Addendum #1	County	Adams
	Local Public Agency	Quincy
September 7, 2016	Project Number	MR 599B
	2016 Capital Roadway Improvements – Wards 4 and 7

2016 Capital Roadway Improvements – Wards 4 and 7

This addendum forms a part of the bidding and contract documents and modifies the original bidding documents dated September 1, 2016. Summary of changes:

FINAL SURVEY		BY	DATE
NOTE BOOK	SURVEYED		
	PLOTTED		
	TEMPLATE		
	AREAS		
NO.	AREAS CHECKED

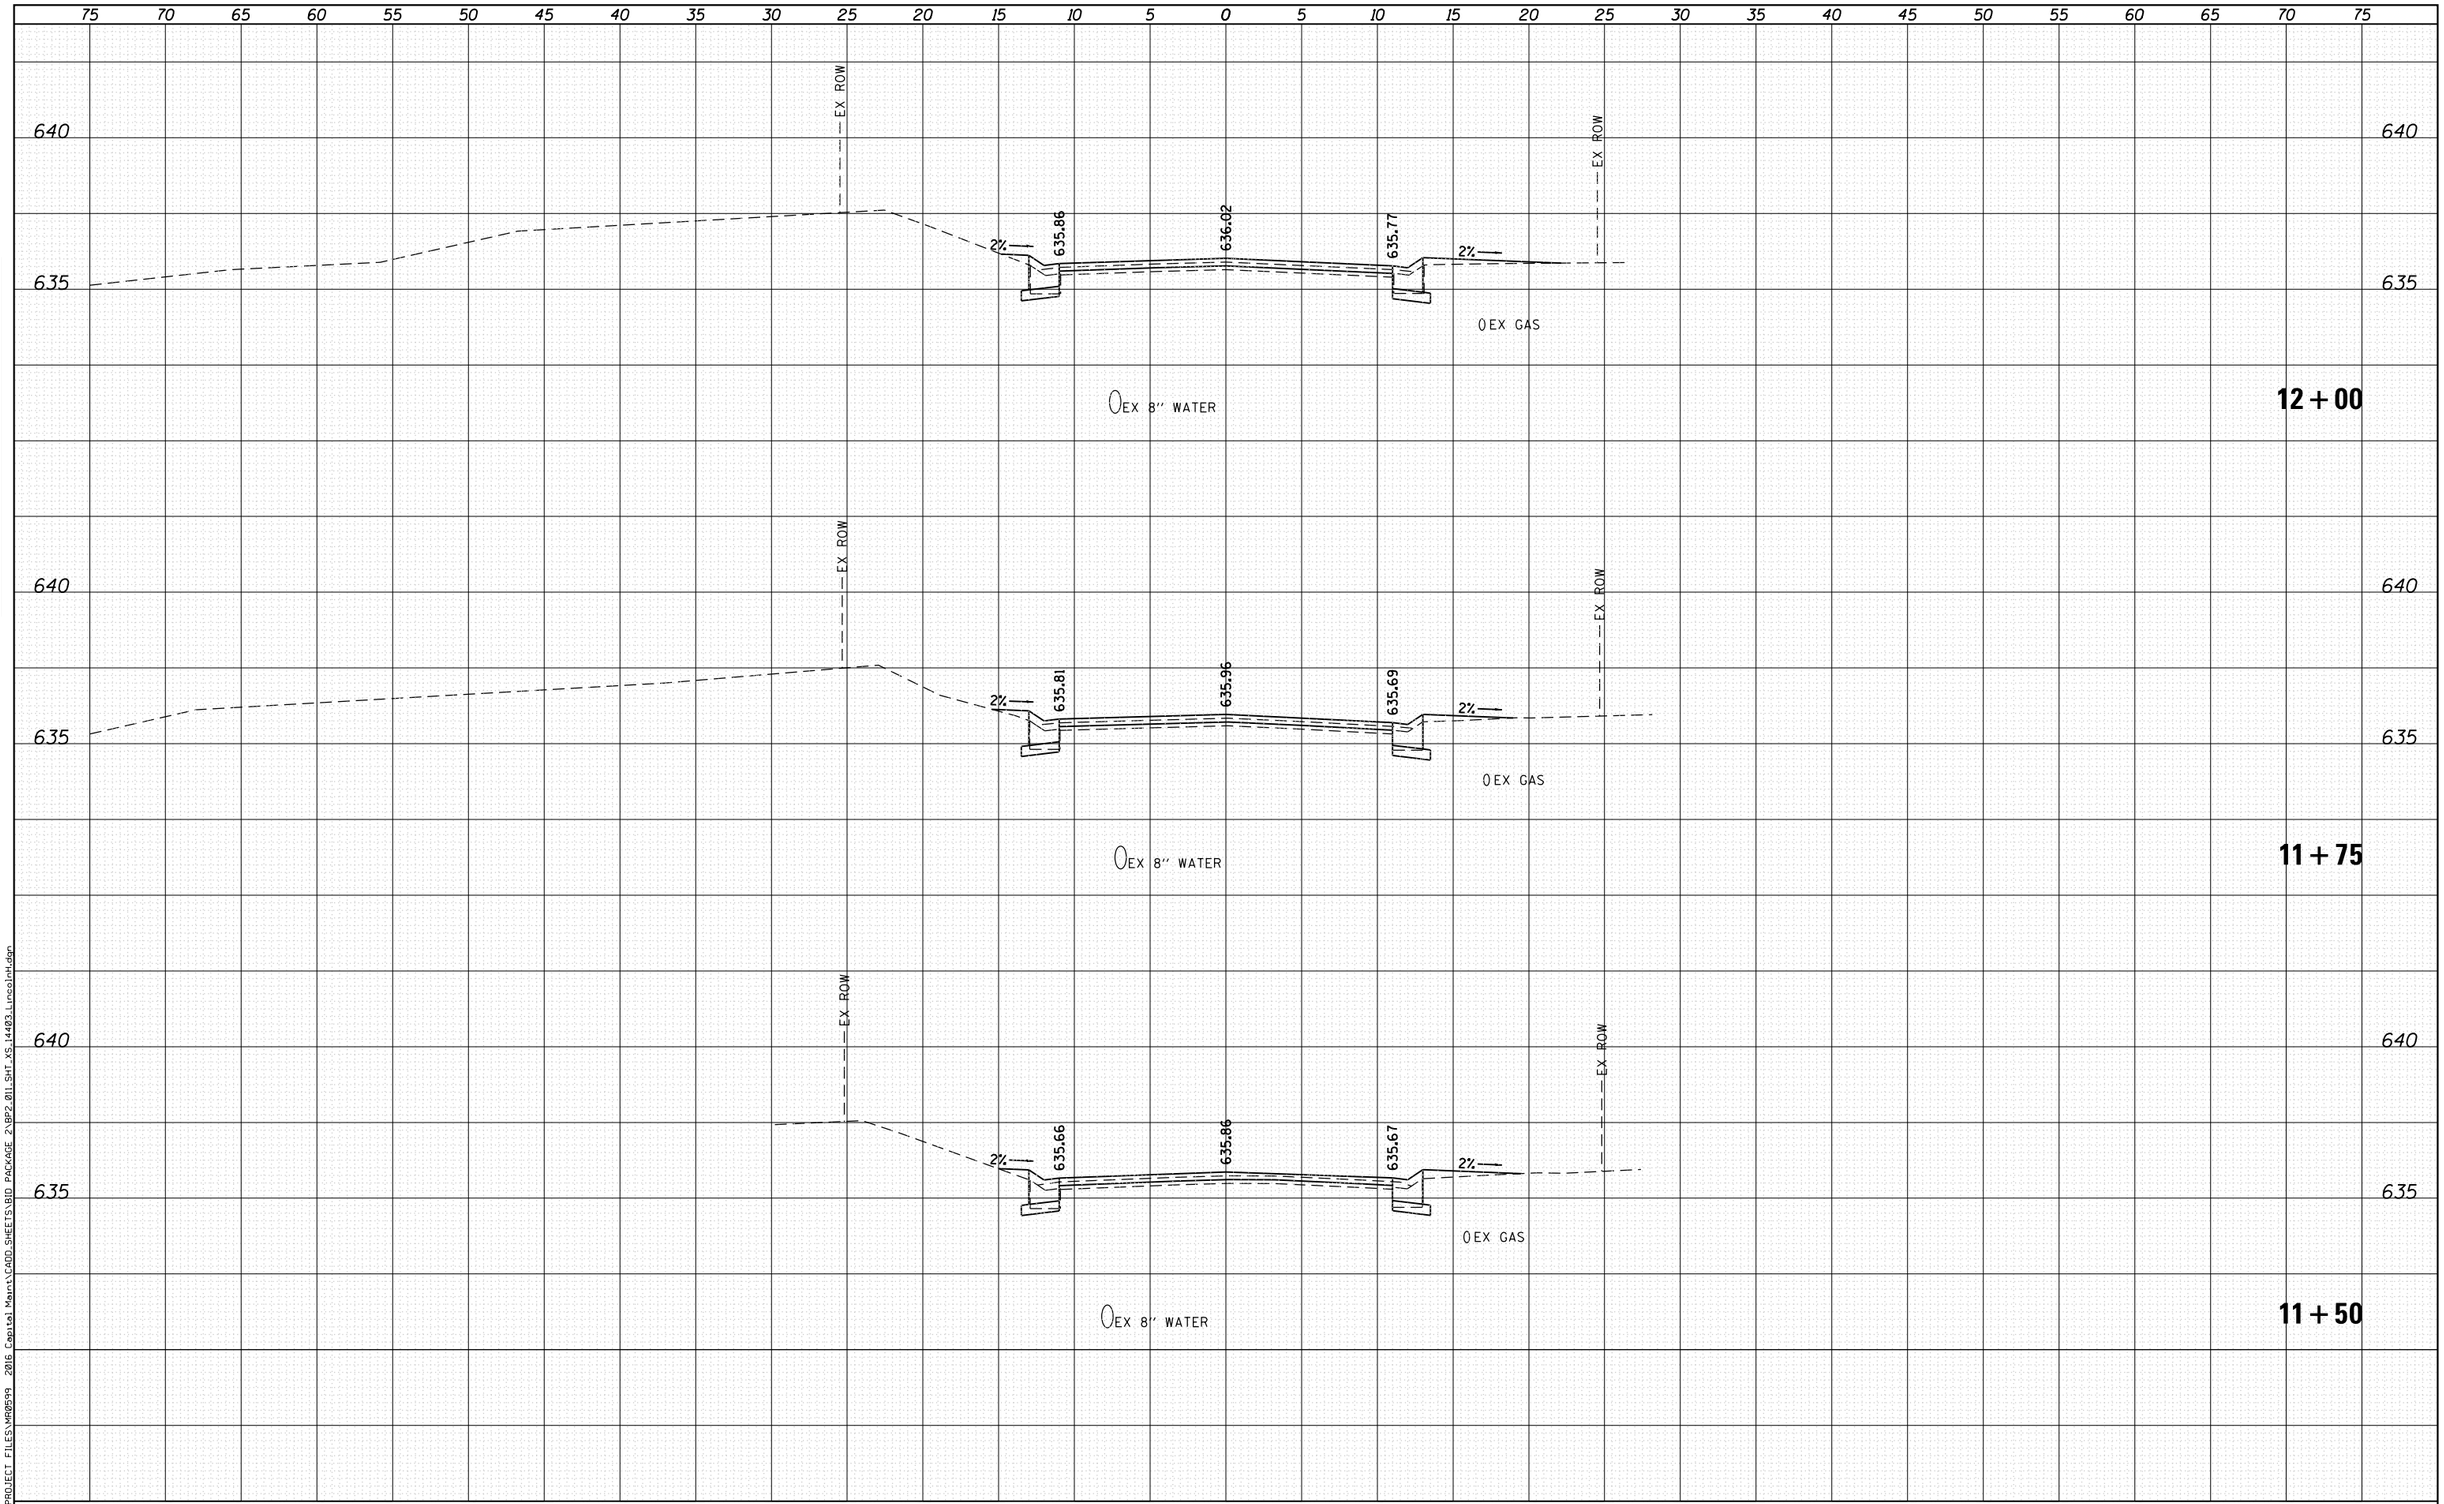
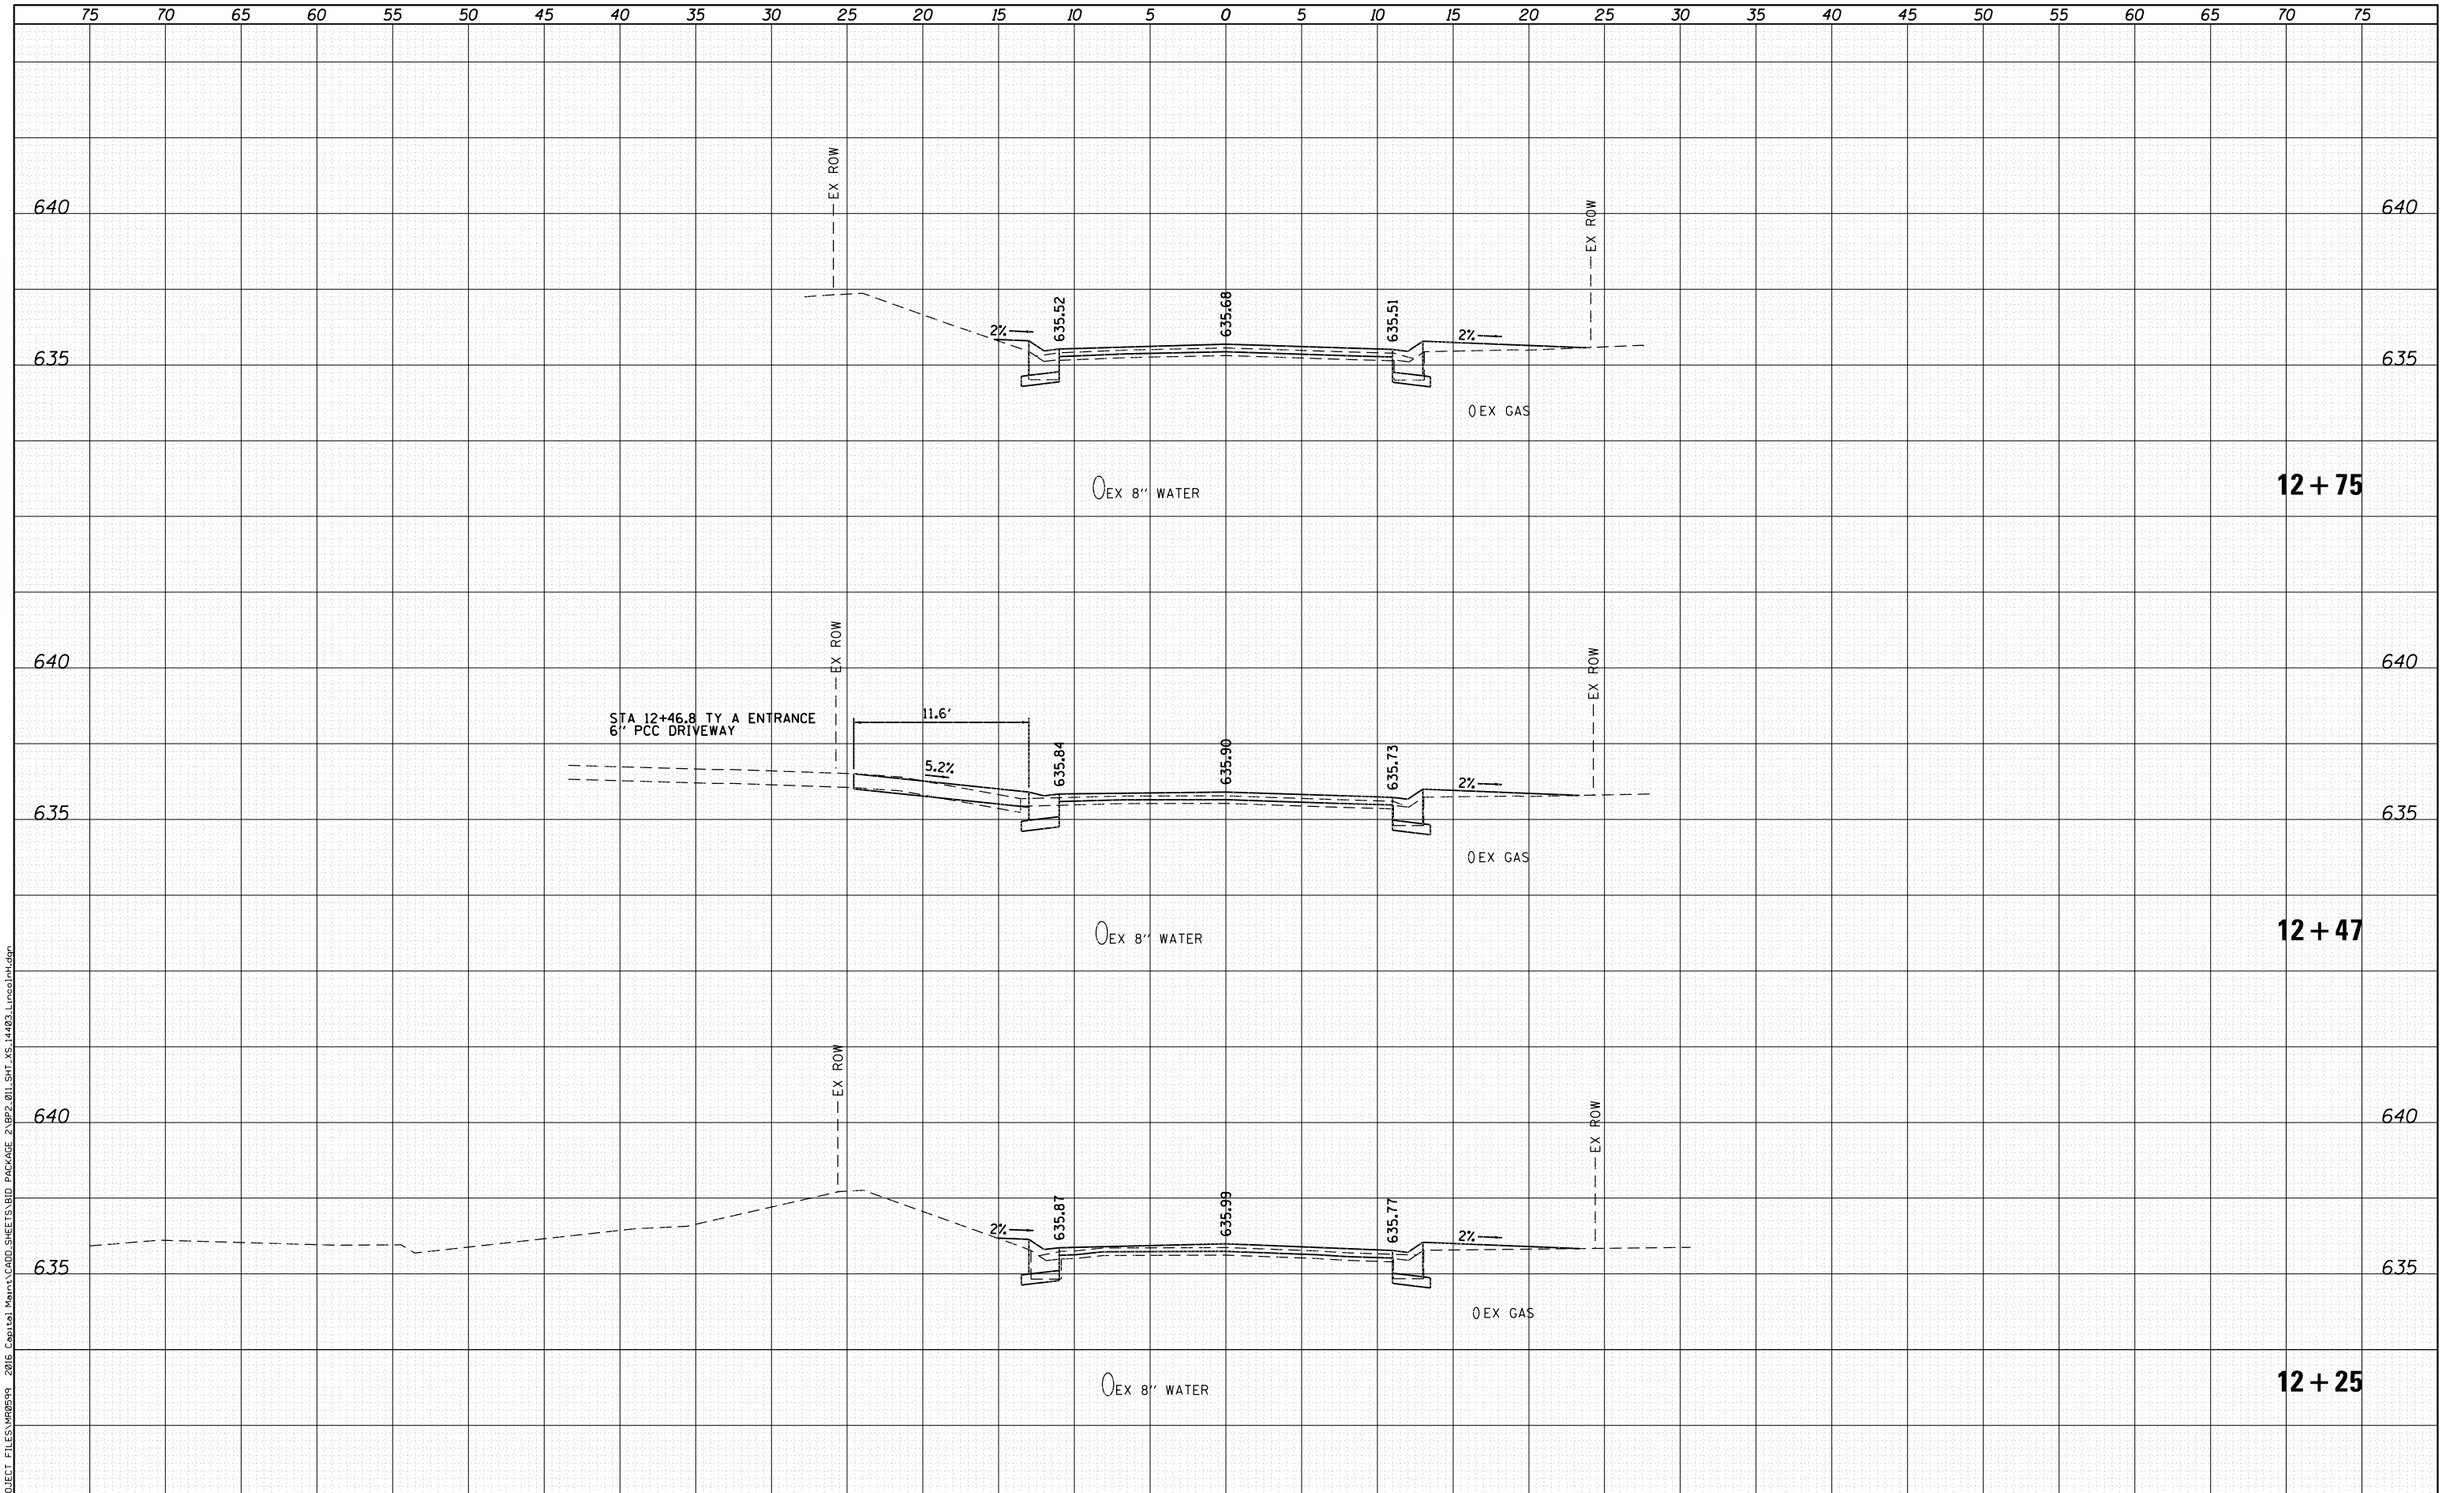
5. **SHEETS 17-23 of 44** - Added elevation labels for the edge of pavement.
